SCSU OLD STUDENT CENTER RENOVATIONS
SCHOOL OF BUSINESS

PROJECT # BI-RS-258

BID OPENING	**1:00 P.M.**	**AUGUST 4, 2010**
ADDENDUM NUMBER NO.2	**DATE OF ADDENDUM**	**JULY 29, 2010**

BID OPENING	**1:00 P.M.**	**AUGUST 4, 2010**
ADDENDUM NUMBER NO.1	**DATE OF ADDENDUM**	**JULY 26, 2010**

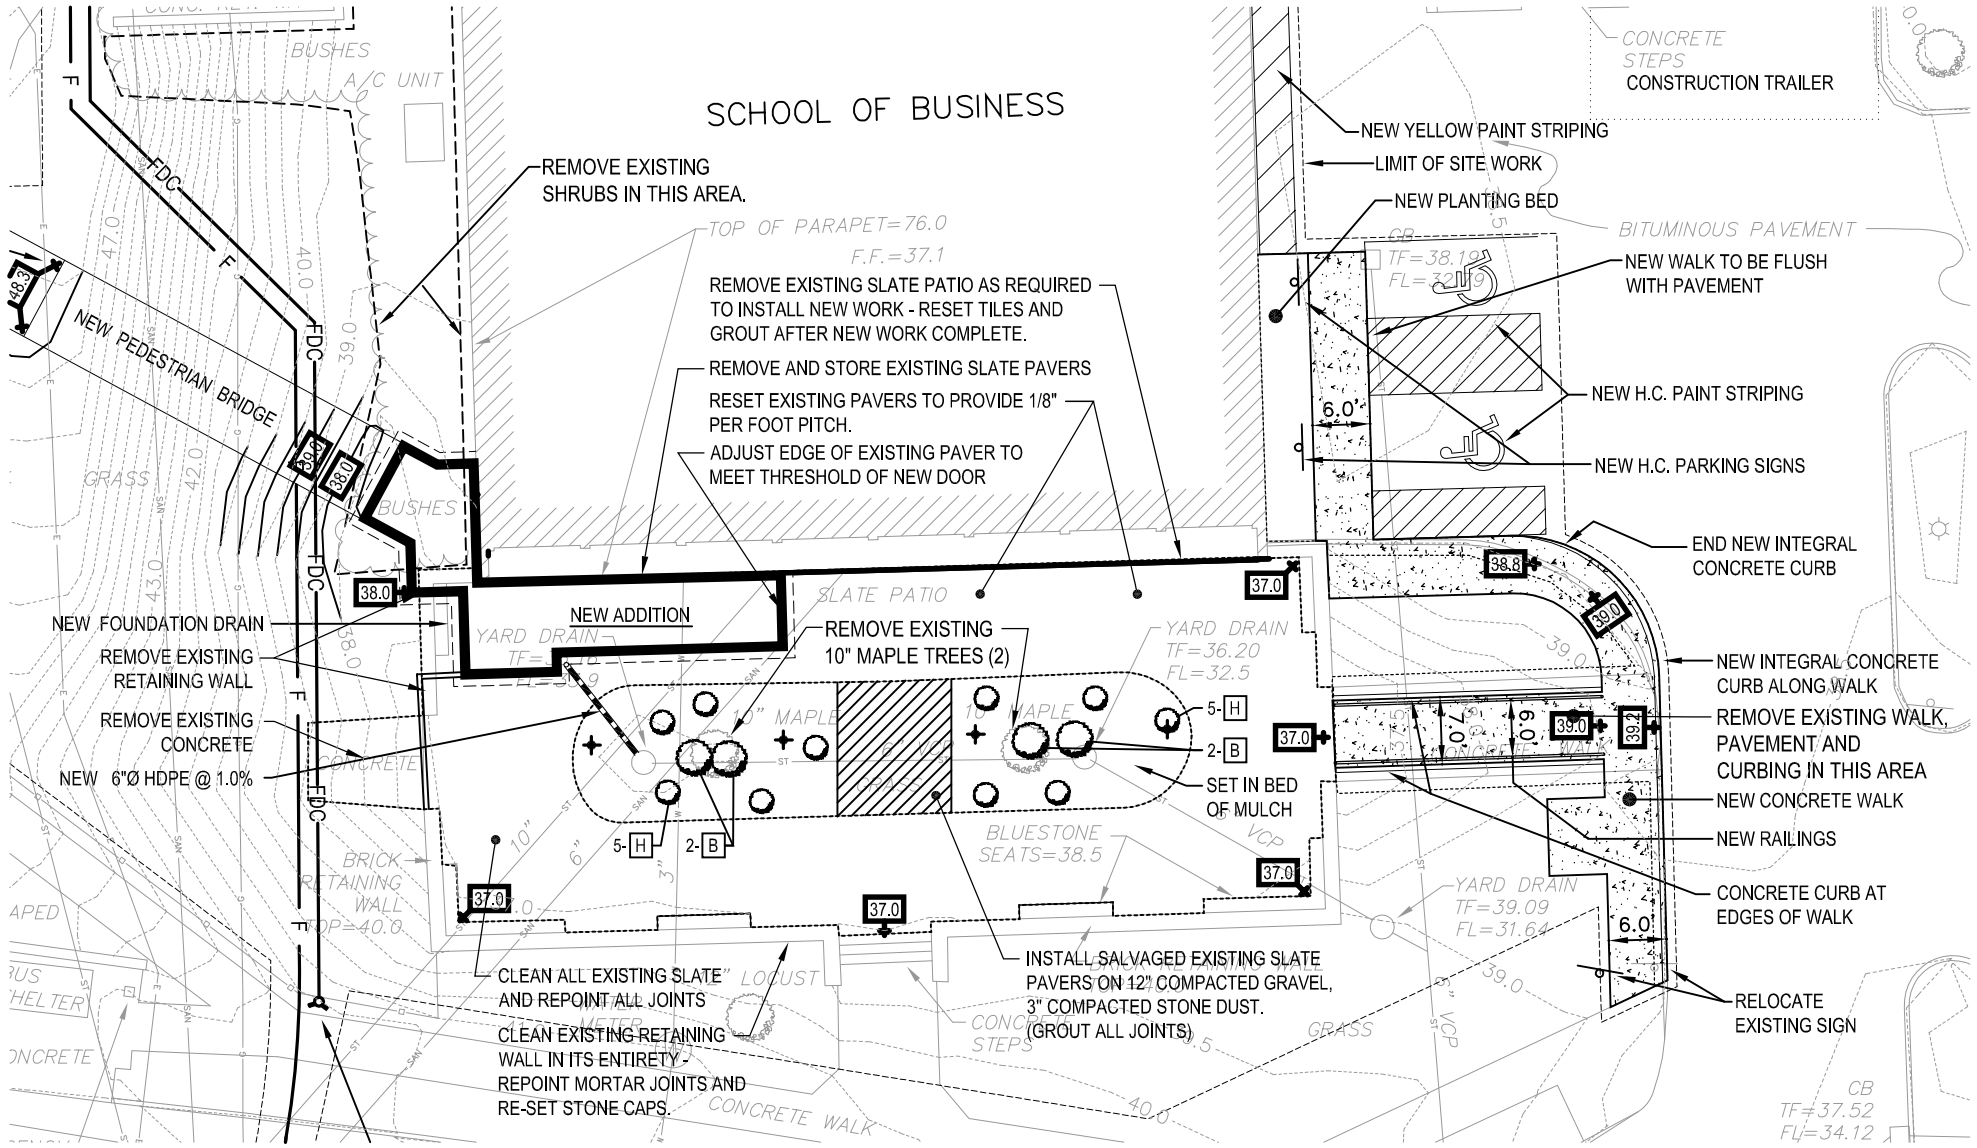
On drawing C.2 can you clarify what the scope of work looks like in the event Supplemental Bid #6 is not accepted? Do the trees remain in the center island area? Do we just patch to match the slate paving once the curtain wall and elevator additions are completed? Will there be any requirement to adjust the grades in the existing areas to meet correctly at the new entry doors? Etc.

All work is shown on SK-01 on the "Base Bid Grading, Utility, and Landscape Plan" dated July 26, 2010. The two 10" maple trees are to be removed in their entirety, patch and or reset slate patio tile as required. Remove and store existing slate pavers and substrate as required to install new wall, elevator, and entrance

vestibule. Repair slate patio at new to existing and install new slate infill from existing salvaged material. Remove and reset existing slate pavers to provide 1/8" per foot away from building perimeter entrance.

On drawing A8.101, "Door & Frame Schedule", dated 2/24/2010, Elevations B10, B8, B7, C10, C8 and all items shown on G10 are hollow metal frames (welded frames).

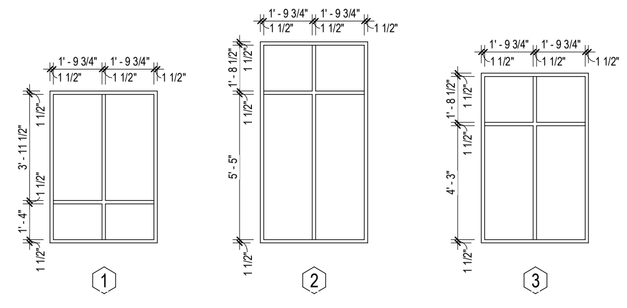
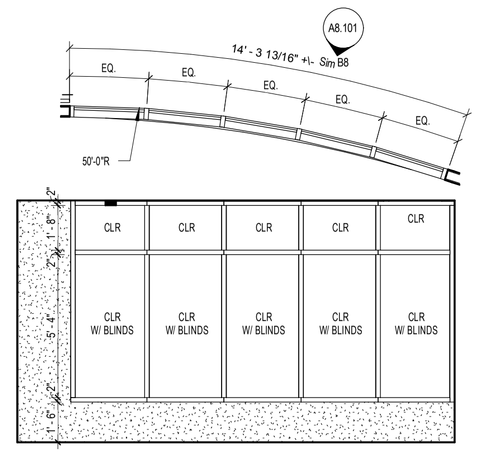
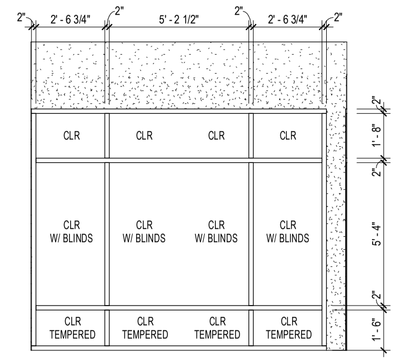
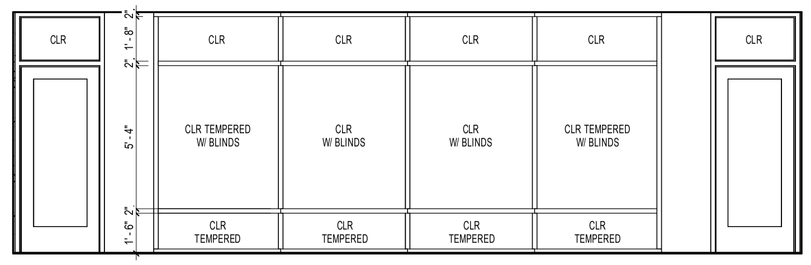
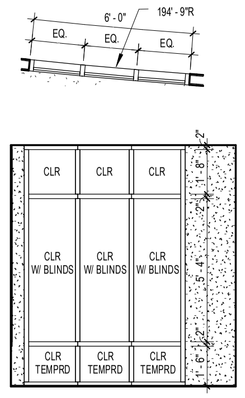
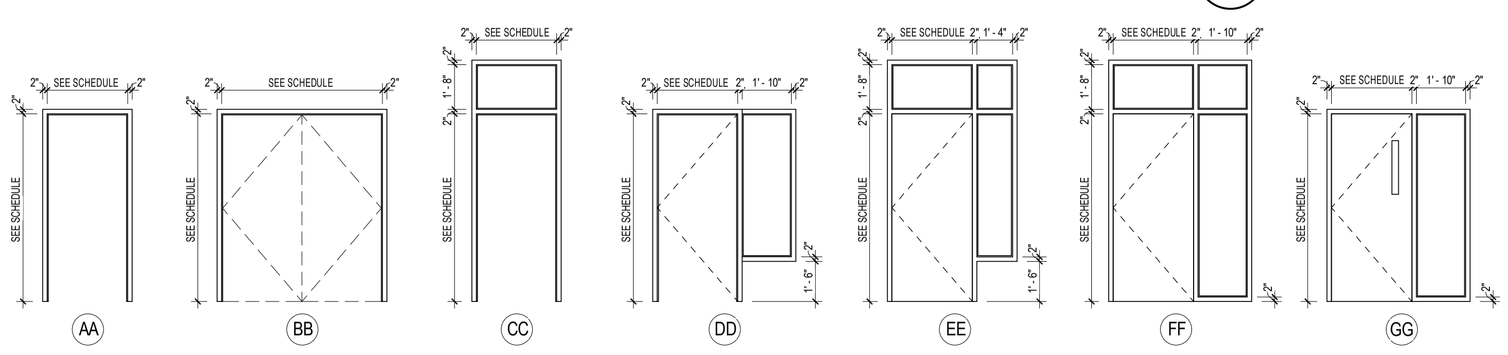
On drawings A8.101 there are a number of window types and elevations indicated on the upper left part of the sheet. There are no sections cut through these windows. Can you please confirm if these are hollow metal frames or aluminum storefront materials?

Drawing A8.101 makes reference to clear glass with blinds at interior frame types B7, B8, C8 and C10. Is this 1/4" glass with blinds by others or a unit with two lites of glass with internal blinds. If so please provide a spec.

Please reference window elevations B7, B8, B10, C8, and C10 on Drawing A8.101. Are these window frames hollow metal, or aluminum, which specification is pertinent to their construction? Are the blinds referenced internal to the glazing, or external field applied window treatments?

All interior hollow metal frames shown on Drawings A8.101 "Door and Frame Schedule" shall receive surface mounted Horizontal Louver Blinds fastened to head of frame. Frames to receive blinds include those shown on B10, B8, B7, C10, C8, and G10 shown on drawing A8.101 "Door and Frame Schedule" dated 2/24/2010. Refer to specification section 12-21-13 Horizontal Louver Blinds.

What type of glazing is used at the transoms and sidelights of door frames, as shown in Detail G10 on A8.101?

E10 DOOR PANEL ELEVATIONS
1/4" = 1'-0"

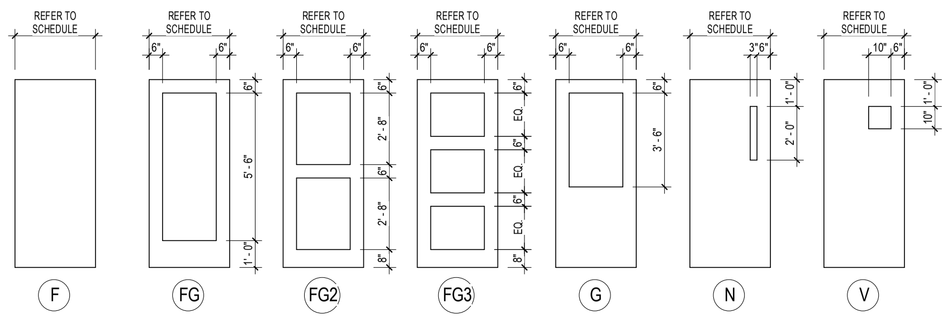
What type of glazing goes into the door panels per Detail E10 on A8.101?

Date: 12/25/09
Scale:
Production Leader:
Project Manager:
Project Architect:
Peer Reviewer:
Drawing Number: SK-1

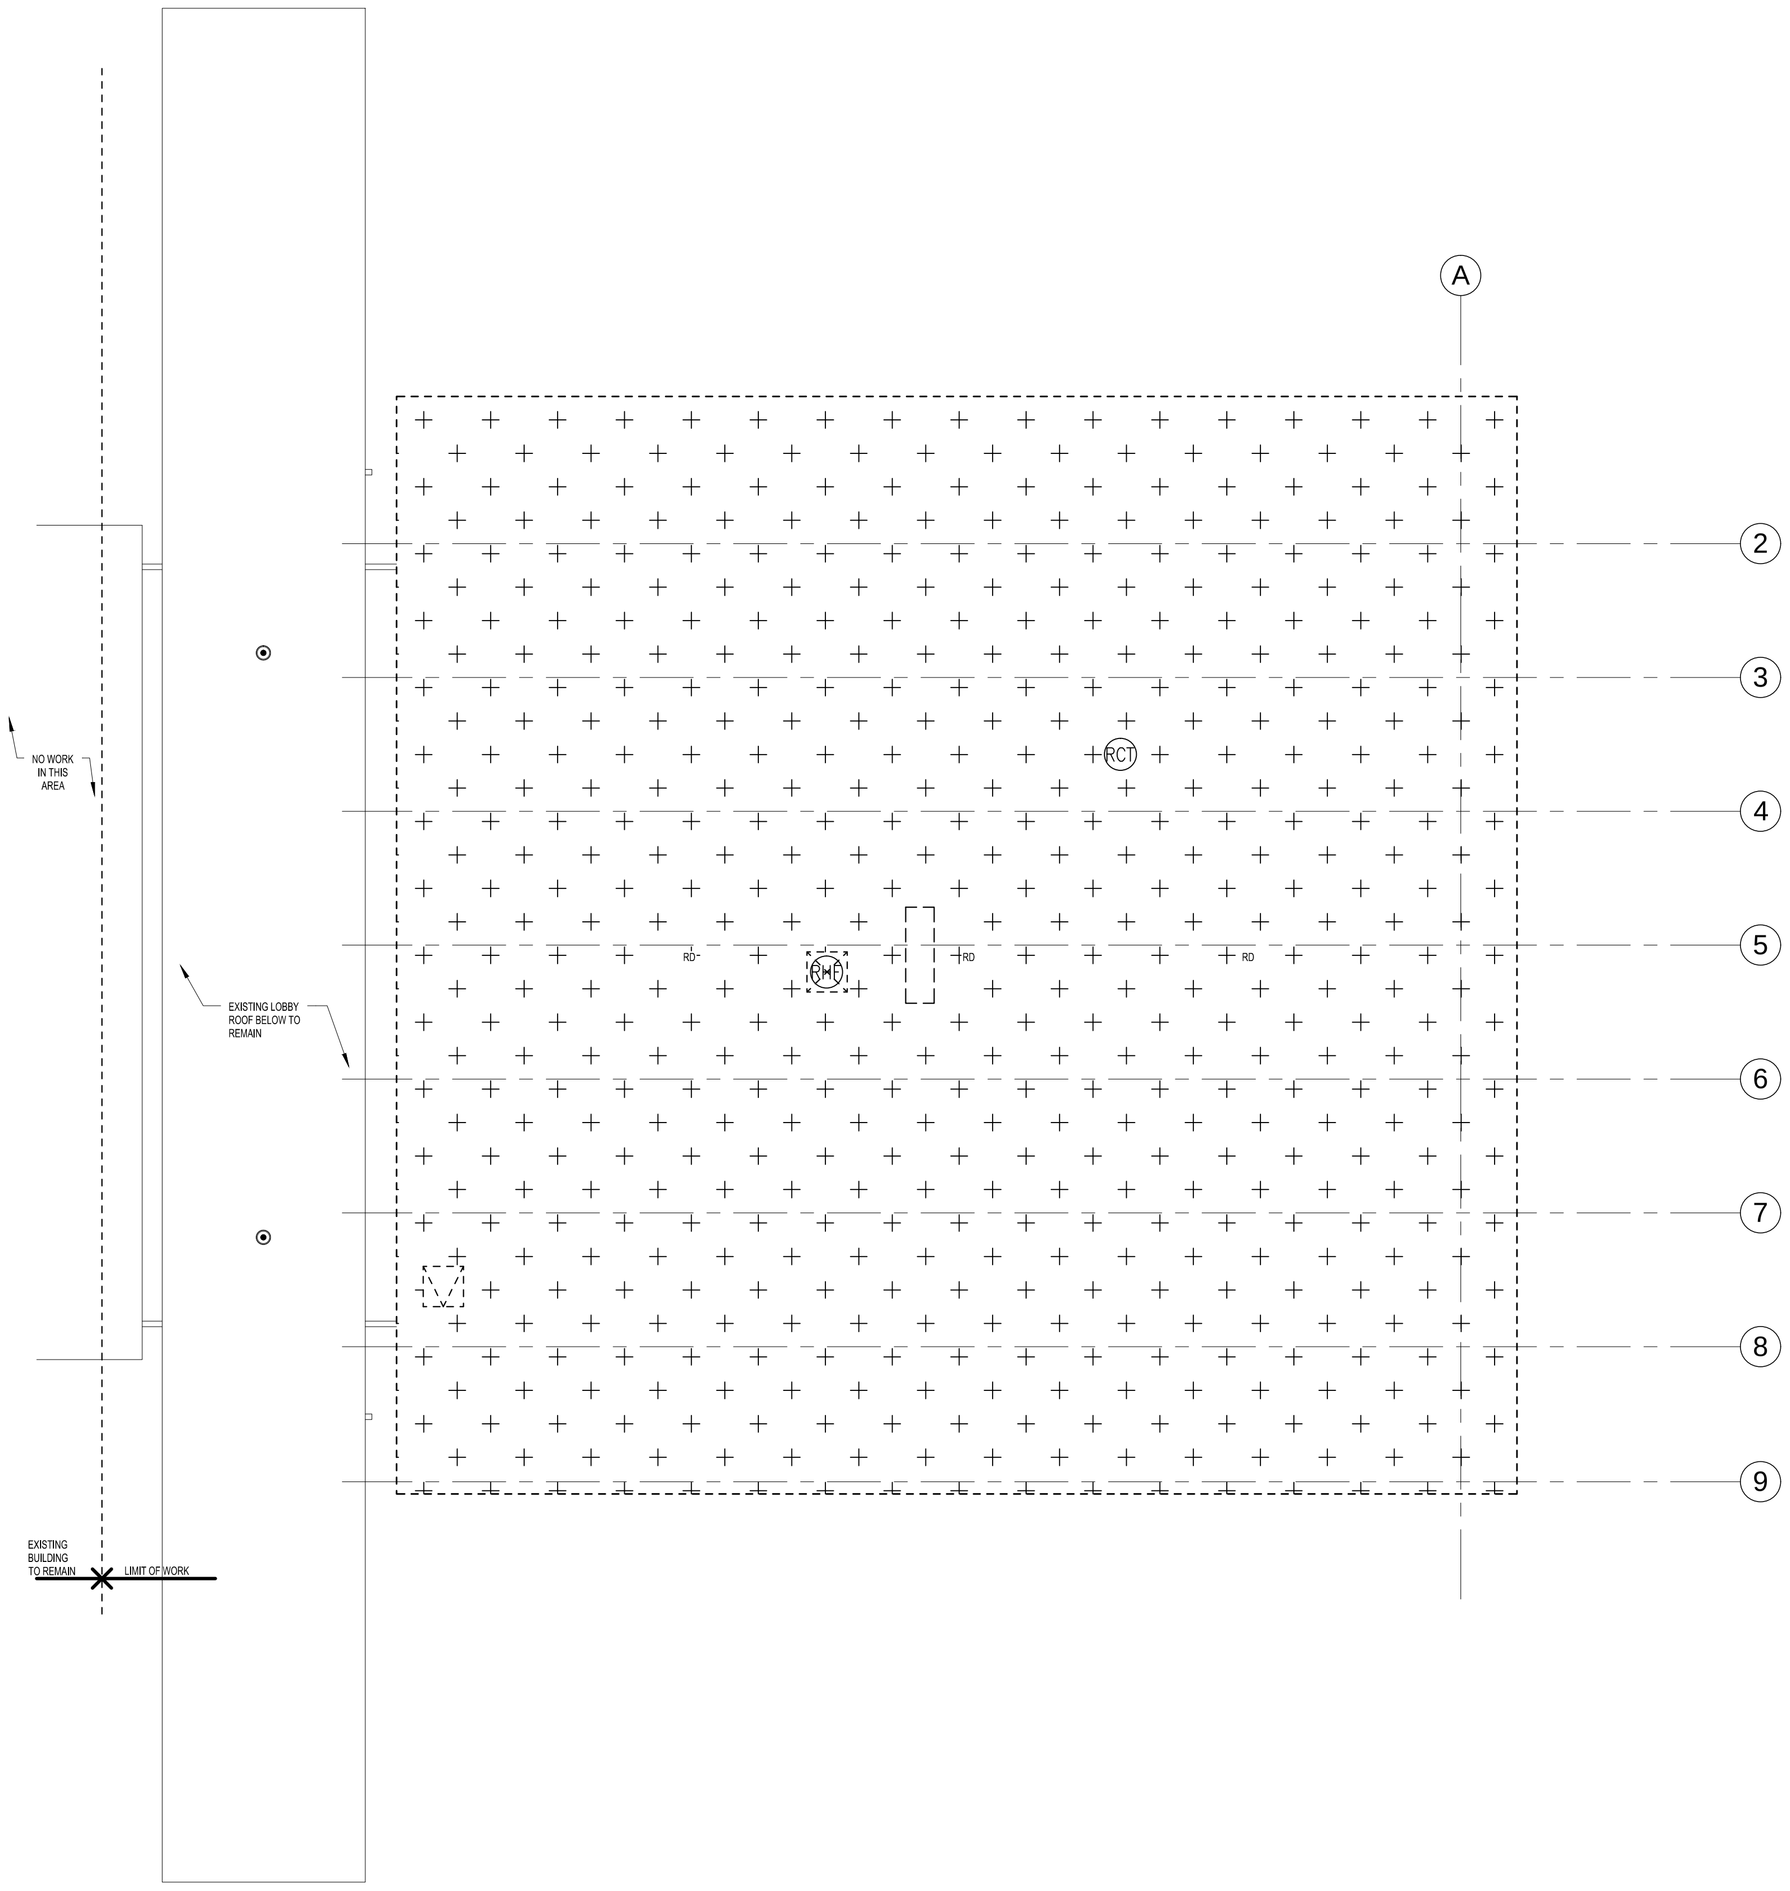
3. All work described on Drawing: SK-1 "Roof Plan", dated 12/25/2009, from ATC Associates Inc. (Project Number RS-09-05)
